Docket Number:	13-AFC-01
Project Title:	Alamitos Energy Center
TN #:	201751
Document Title:	Data Adequacy Supplement
Description:	N/A
Filer:	Elizabeth Smoker
Organization:	CH2M HILL
Submitter Role:	Applicant Consultant
Submission Date:	2/17/2014 1:21:17 PM
Docketed Date:	2/18/2014

**Re: Alamos Energy Center (13-AFC-01)
Data Adequacy Supplement**

Data Adequacy Supplement

**Alamitos Energy Center
(13-AFC-01)**

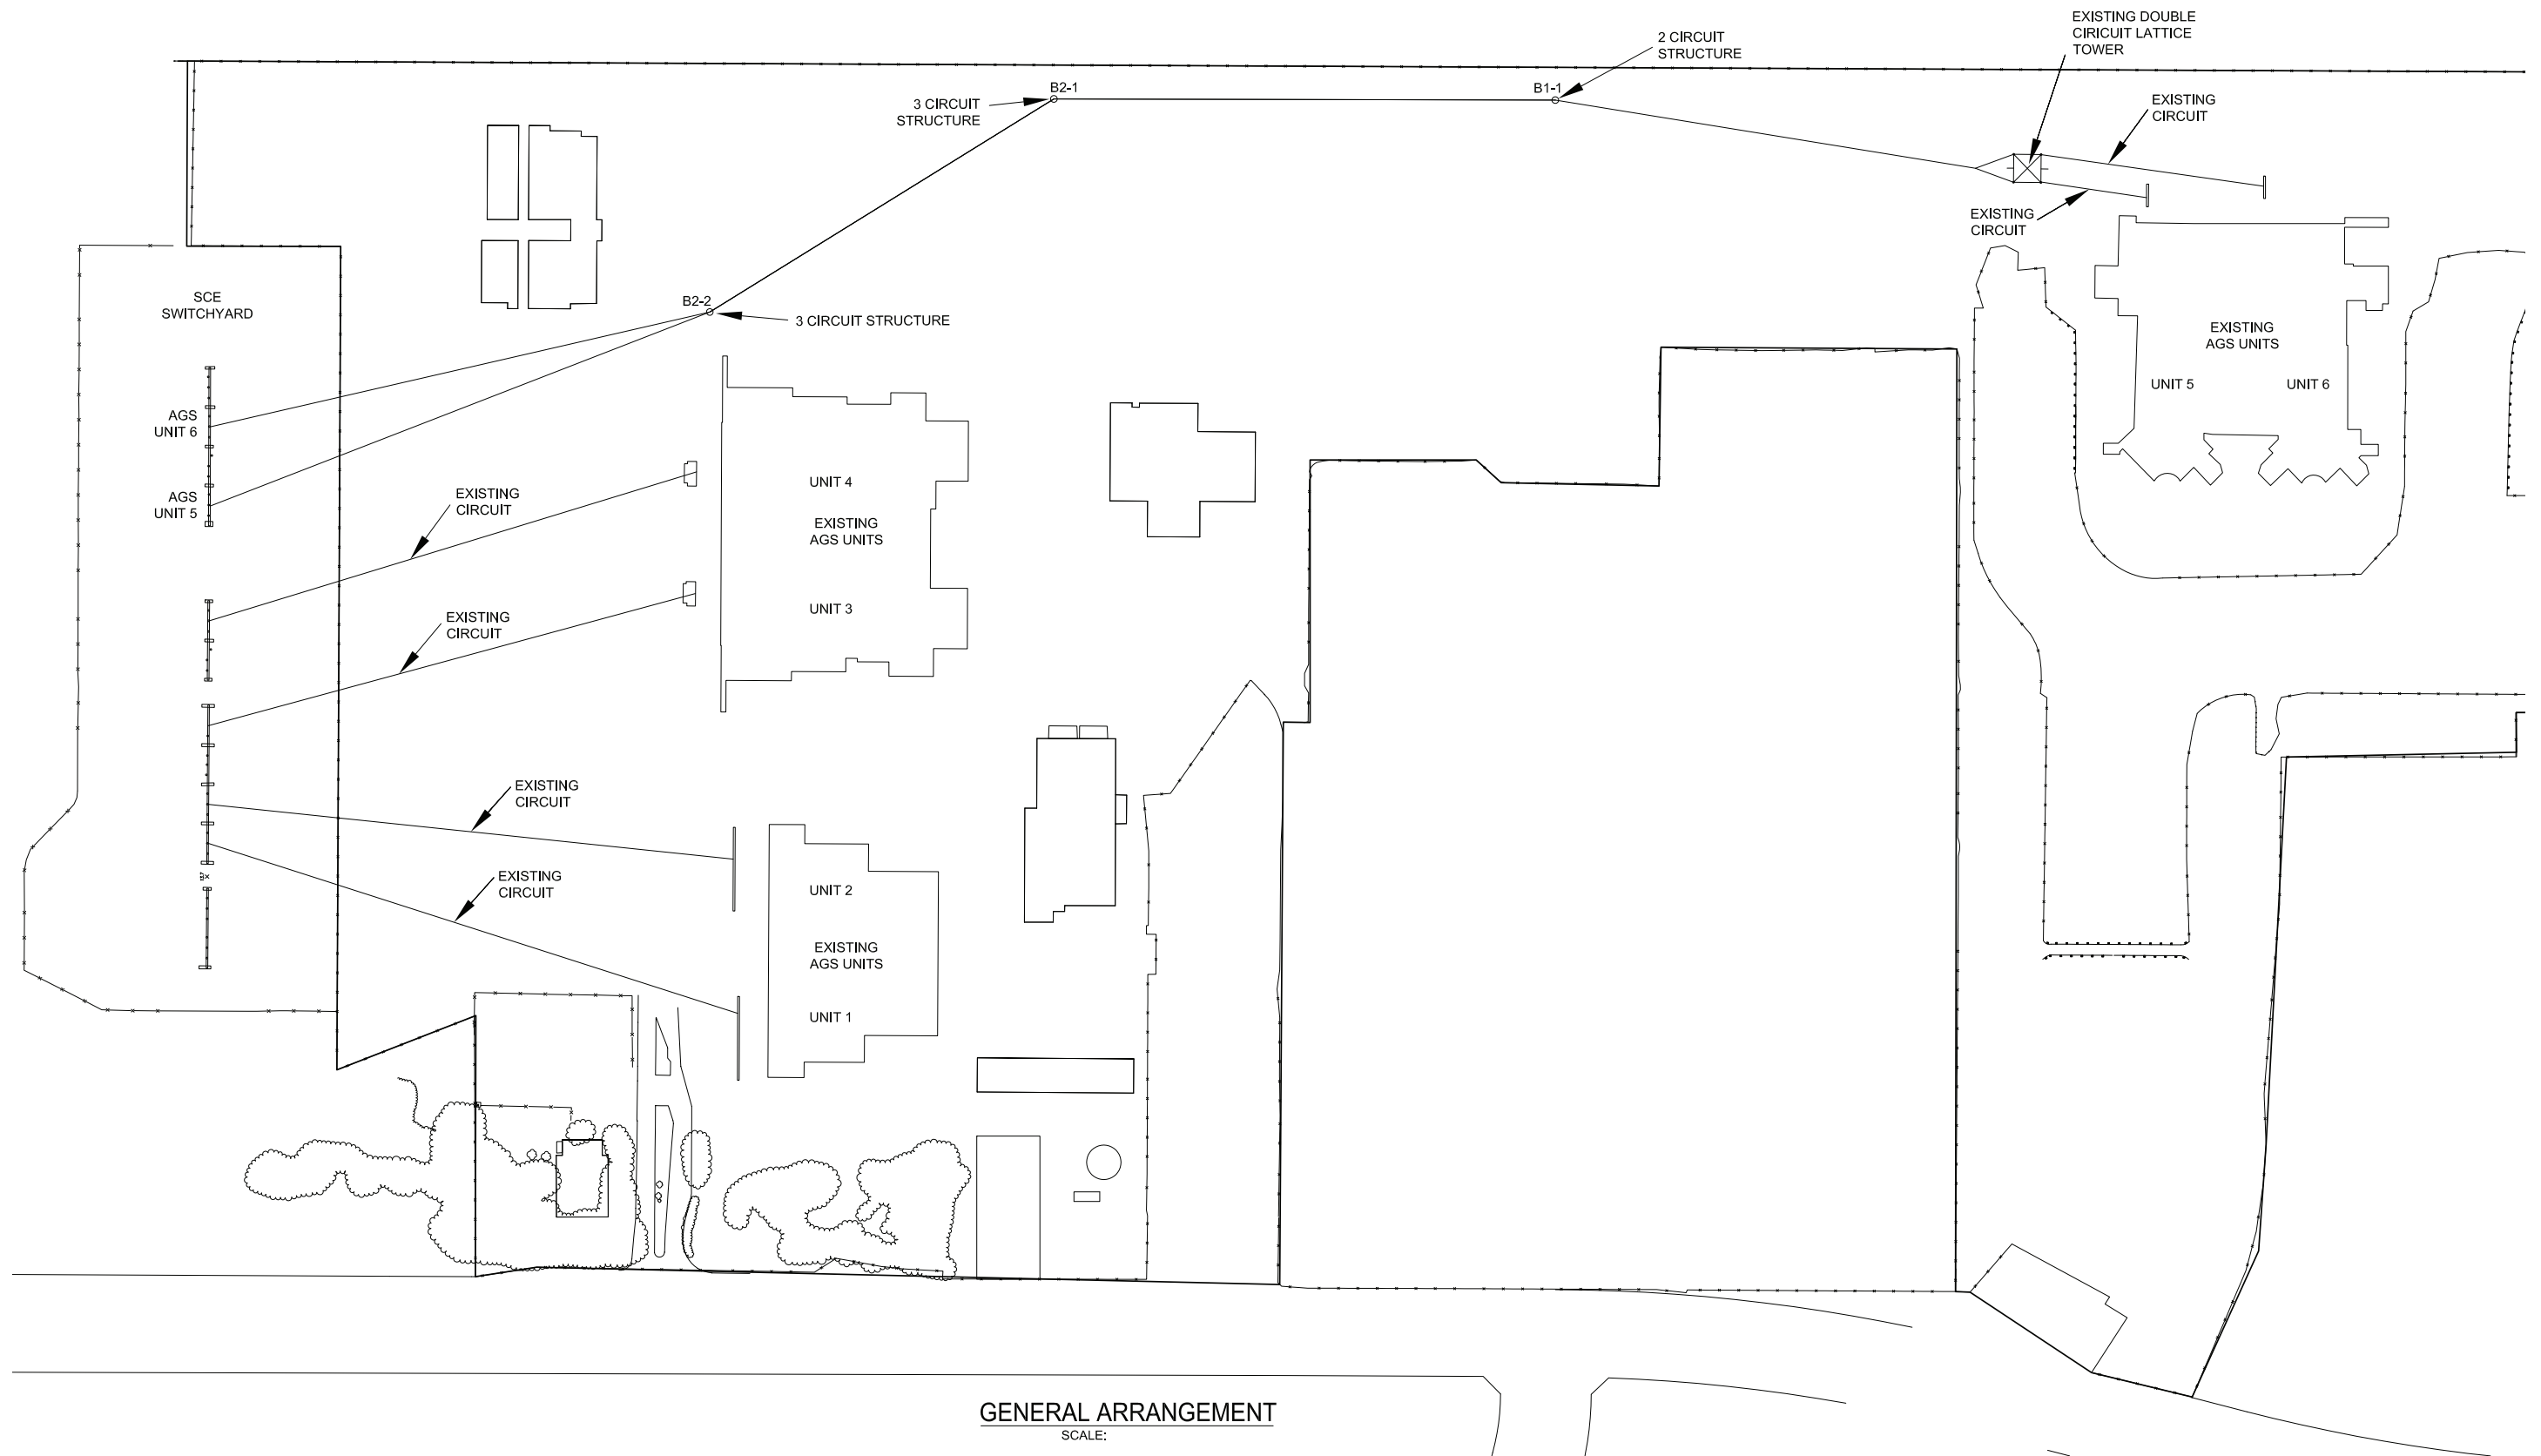
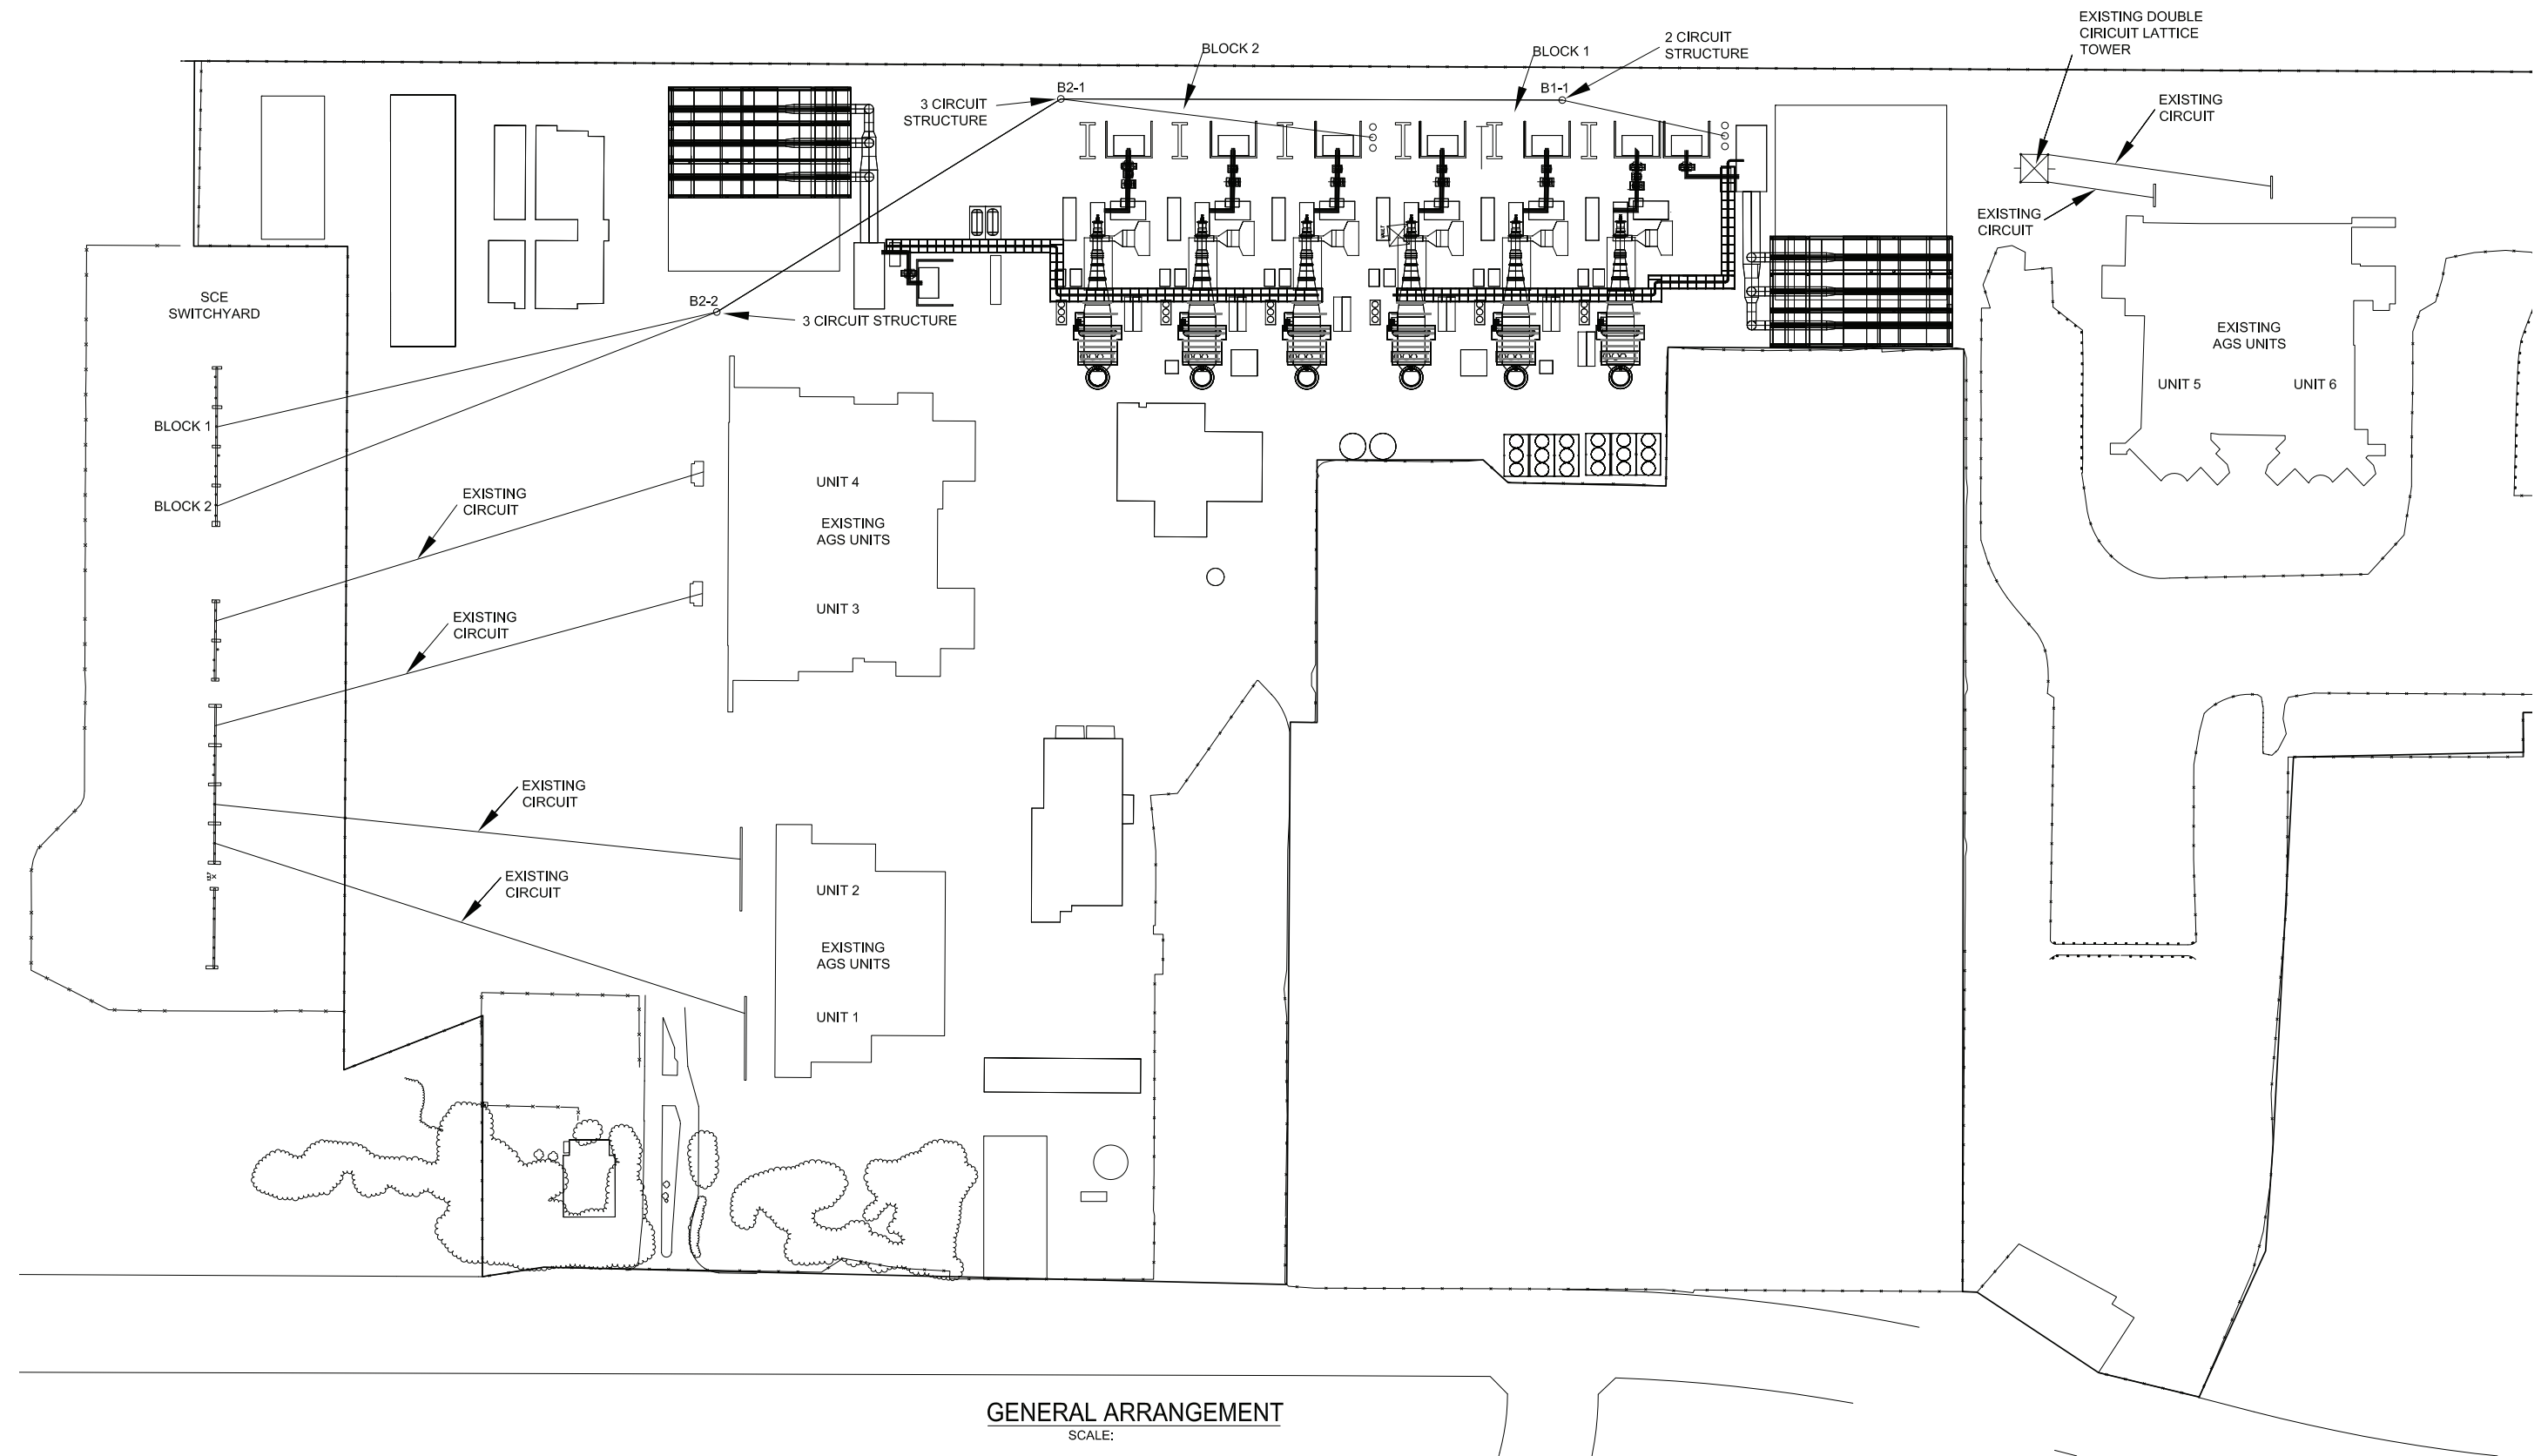
Submit three sets of pre and post-project physical layout drawings of the plant (similar to Fig. 2.1-2) according to the Table 2.2-1 project schedule with three major milestone dates which are: second quarter of 2019, third quarter of 2022, and fourth quarter of 2025.

Attachment DA3.0-1 includes three sets of the five physical layout figures at select stages of AEC's construction. Figure DA3.0-1a shows the existing site and electrical interconnections prior to construction. Figure DA3.0-1b, representing the second quarter 2016, shows the existing site with Unit 7 demolition completed and the rerouting of the Alamitos Generating Station Units 5 and 6 interconnection line completed. Note that all three of Units 5 and 6 interconnection towers are replaced by transmission towers that will ultimately be used by AEC's Blocks 1, 2 and 3. Figure DA3.0-1c, representing the second quarter 2019, shows AEC Blocks 1 and 2 interconnected to the SCE switchyard using the transmission towers installed previously. The interconnection line for Units 5 and 6 is not shown on this figure as these units are scheduled for demolition starting in August 2018. Figure DA3.0-1d, representing third quarter 2022, shows AEC Block 3 interconnected to the SCE switchyard, again using the transmission towers previously constructed. Figure DA3.0-1e, representing the fourth quarter 2025, shows AEC Block 4 interconnected to the SCE switchyard.
